Item ID: D350-607-511 Accept ***N900040100*** Setup Start ***NS1***
 Revision ID: Stop ***NS2***
 Item Name: Quick Release Basket and Long Cargo Tube Mounting Provisions, Fits LH or RH
 Start Date: 10/26/2015 Start Qty: 2.00 ***2*** Cust Item ID:
 Required Date: 11/3/2015 Req'd Qty: 2.00 ***2*** Customer:
 Reference:

DART SERVICE INSTRUCTION

TO AMEND INSTALLATION INSTRUCTIONS D350-607-3 Rev.D,
INSTALLATION INSTRUCTIONS D350-607-4 Rev. C AND
INSTRUCTIONS FOR CONTINUED AIRWORTHINESS ICA-D350-607 REV. 6
REF TCCA STC: SH94-14
REF FAA STC: SR00213NY
REF EASA STC: EASA.10016996
REF BRAZILIAN STC: 2007S03-03/-04/-05/-06

FIGURE 1: INSTALLATION OF D4775-041 FWD STRUT

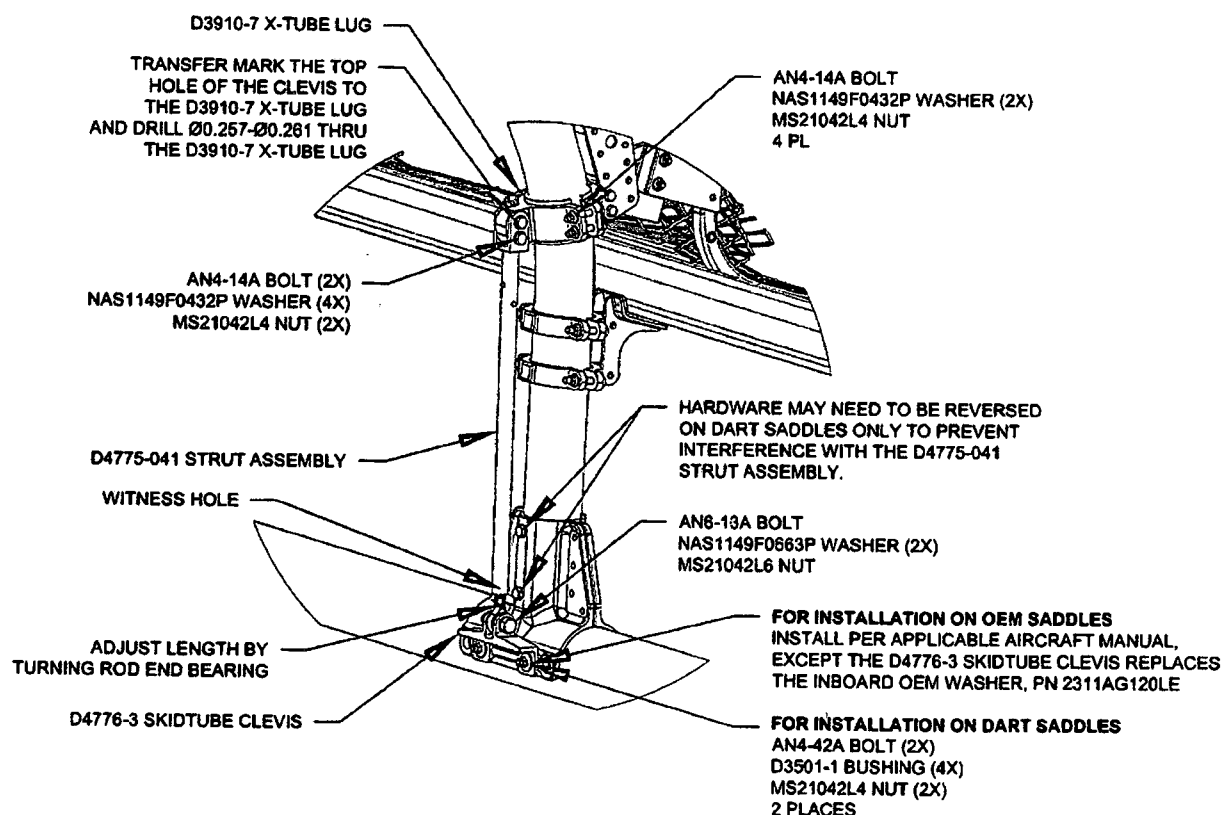
- 3.1 Substitute the Forward Lower D3910-5 X-Tube Lug with the D3910-7 X-Tube Lug as shown in Figure 1.
- 3.2 Install the forward D4775-041 Strut Assembly. Transfer mark from the upper hole on the clevis of the D4775-041 Strut Assembly to the D3910-7 X-tube Lug and drill thru the lug $\varnothing 0.257$ - $\varnothing 0.261$ as shown in Figure 1. Touch up chemical conversion coating per MIL-DTL-5541. Check the witness holes located at the bottom end of the D4775-041 Strut Assemblies to ensure that the thread from the rod end extends past the witness hole.
Torque MS21042L4/-4 nuts to 50-70 in-lbs (5.7-7.9 N-m). Torque MS21042L6/-6 nuts to 160-190 in-lbs (18.1-21.5 N-m).
- 3.3 Complete the installation in accordance with Installation Instructions D350-607-3 Rev. D or D350-607-4 Rev. C.
